URGENT MEDICAL DEVICE CORRECTION NOTICE

**For MEDFUSION® SYRINGE INFUSION PUMP, MODELS 3010 AND 3010a WITH
OBSOLETE SOFTWARE VERSIONS 2.0.2, 2.0.3, AND 2.0.4**

June 22, 2010

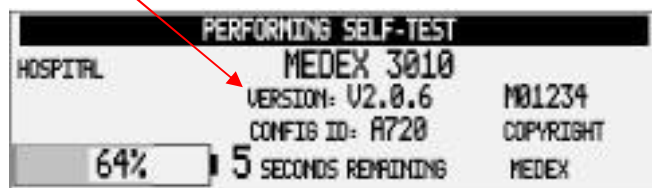
Smiths Medical has found that pumps with obsolete software may continue to run past the set volume limit, if all of the following occur:

- 1) The Volume Over Time (delivery method) mode is used;
- 2) The Volume Over Time mode is re-accessed through the Recall Last Settings function; and
- 3) The syringe is over-filled (e.g., the syringe is filled for more than one infusion amount).

Subject to this Urgent Medical Device Correction Notice, Smiths Medical is requiring its customers with Medfusion® Model 3010 and 3010a pump software versions 2.0.2, 2.0.3, or 2.0.4 to upgrade their software to the current version 2.0.6.
